**Rancho Las Virgenes
Regional Facilities Expansion IV**

Solids Handling and Composting Facilities

LAS VIRGENES MWD / TRIUNFO CSD
RANCHO LAS VIRGENES - REGIONAL FACILITIES EXPANSION IV
SOLIDS HANDLING AND COMPOSTING FACILITIES

ANAEROBIC DIGESTERS AND
 DIGESTER PUMP STATION

ROOF FRAMING PLAN
SCALE: 1/4" = 1'-0"

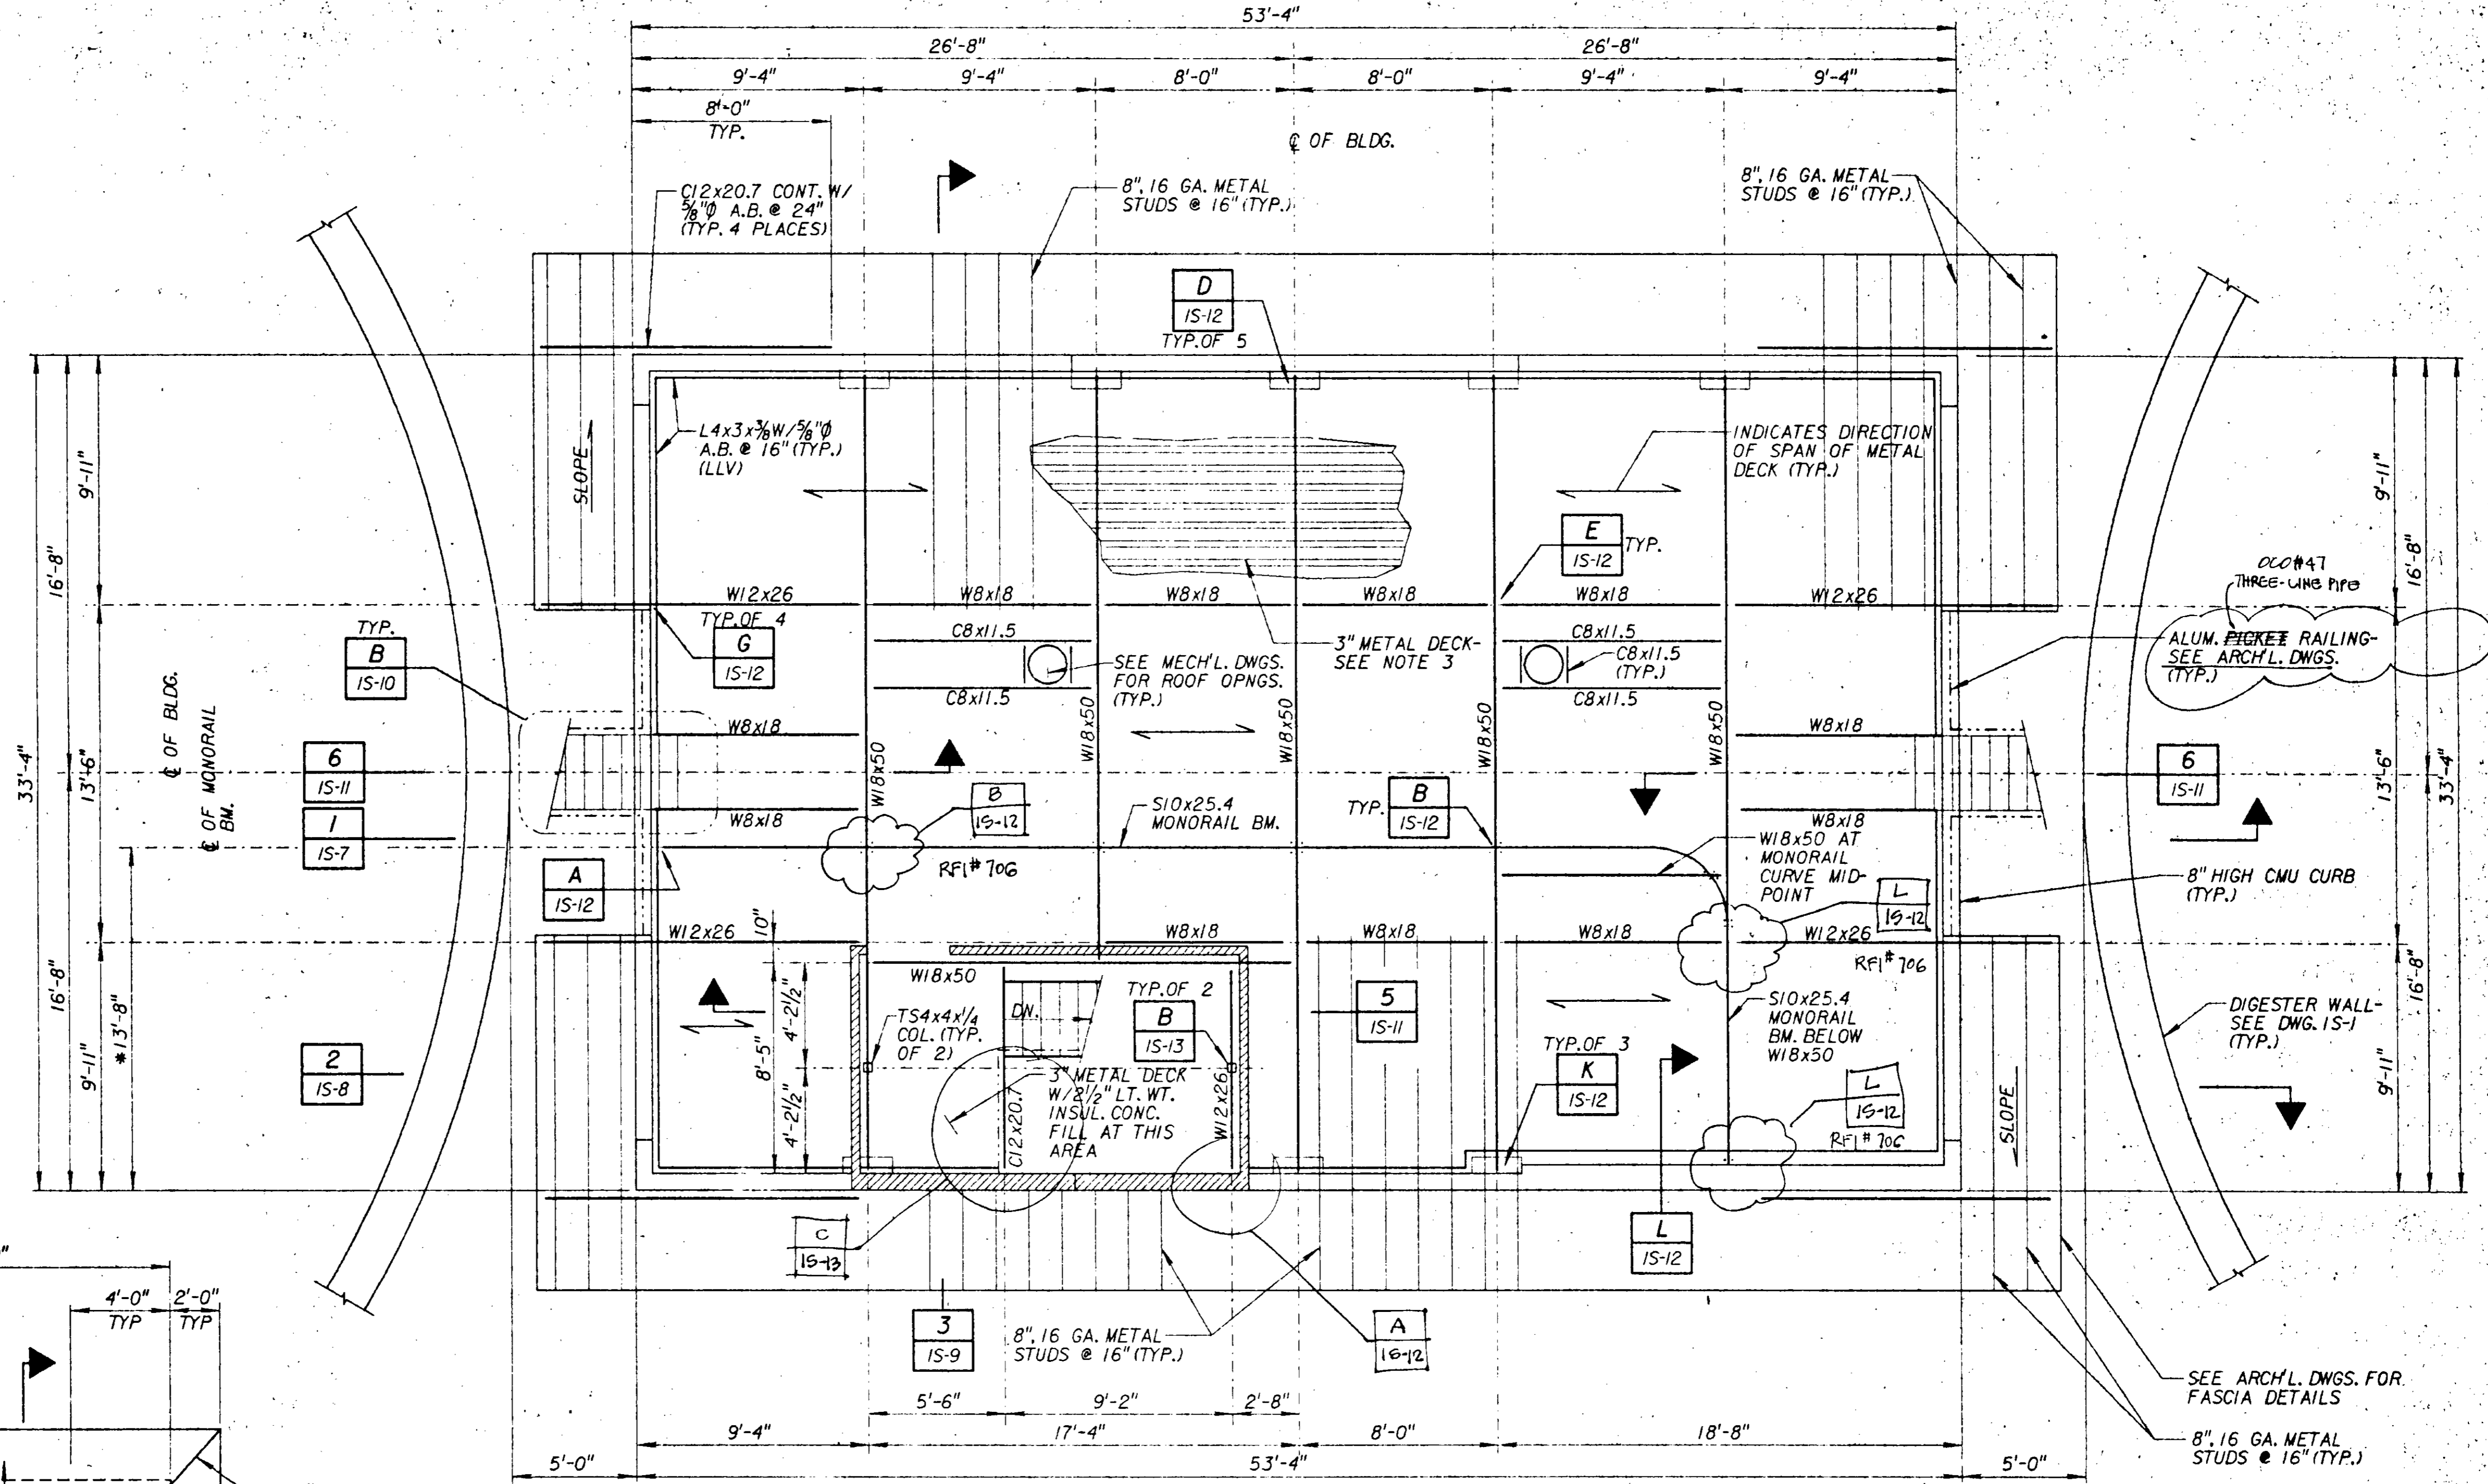
RFI #706 ALLOWS 24-12 SELF-DRILLING SCREWS TO REPLACE PUDDLE WELDS ON DECK TO JOIST CONNECTIONS.

SECTION 1
SCALE: 3/8" = 1'-0"
15-5 15-6

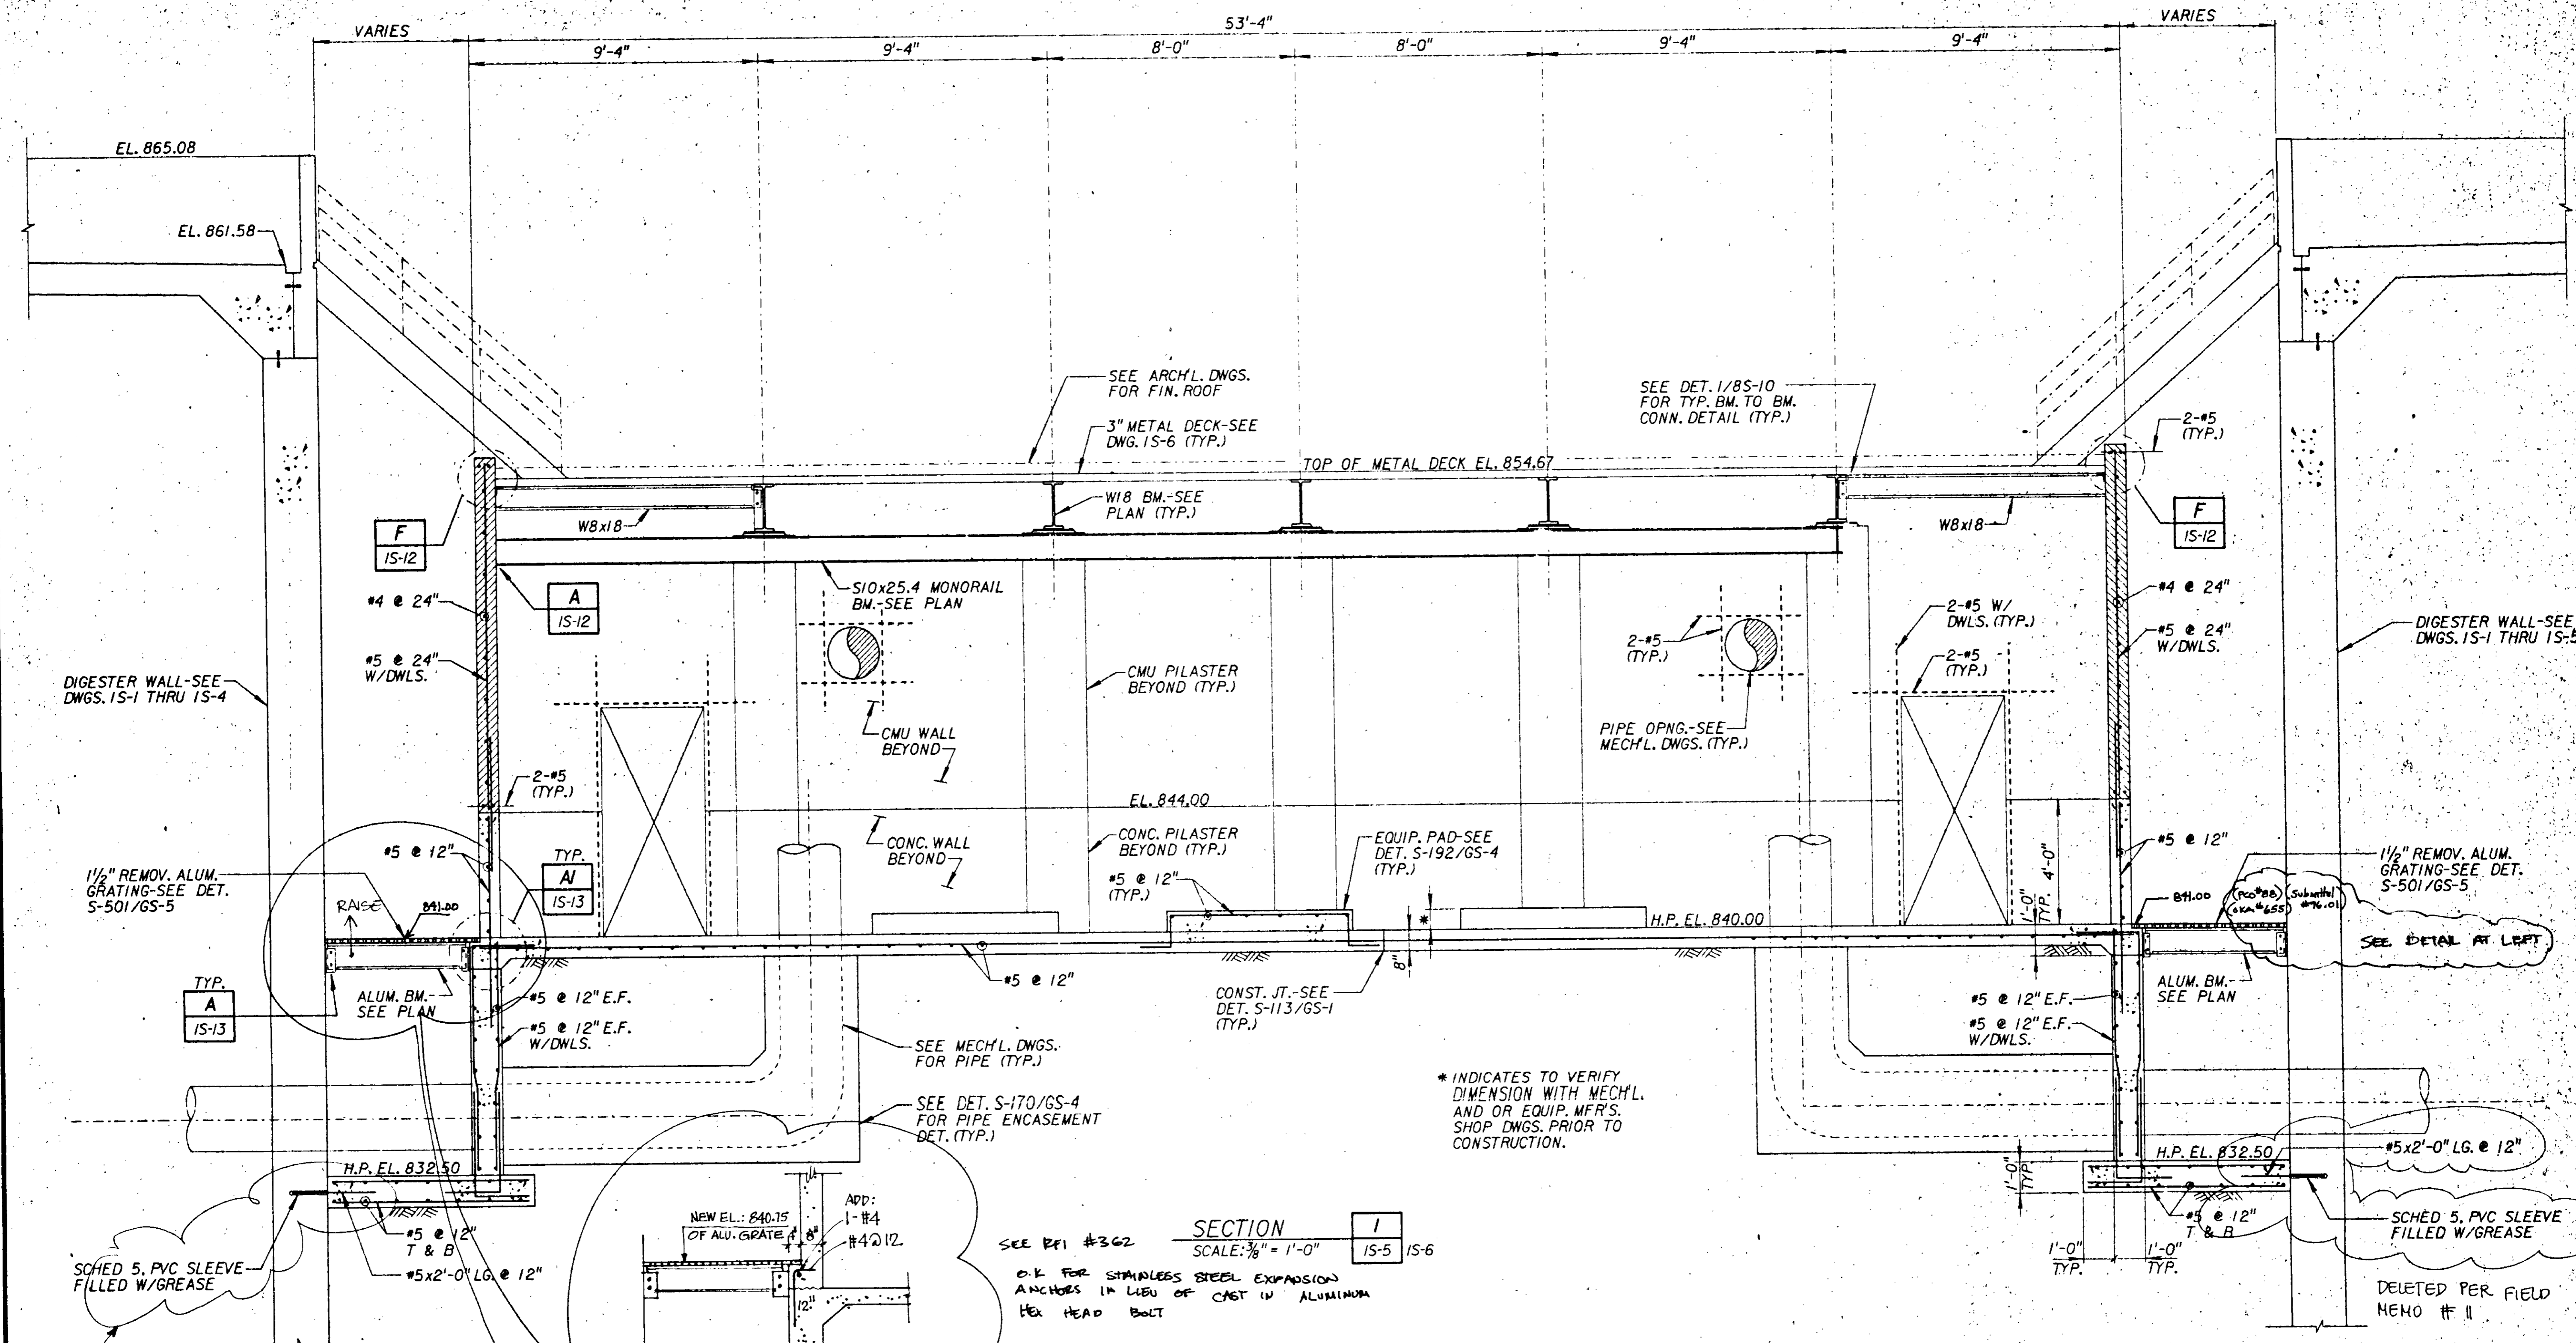
SEE REF #362
O.K. FOR STAINLESS STEEL EXPANSION ANCHORS IN LIEU OF CAST IN ALUMINUM HEX HEAD BOLT
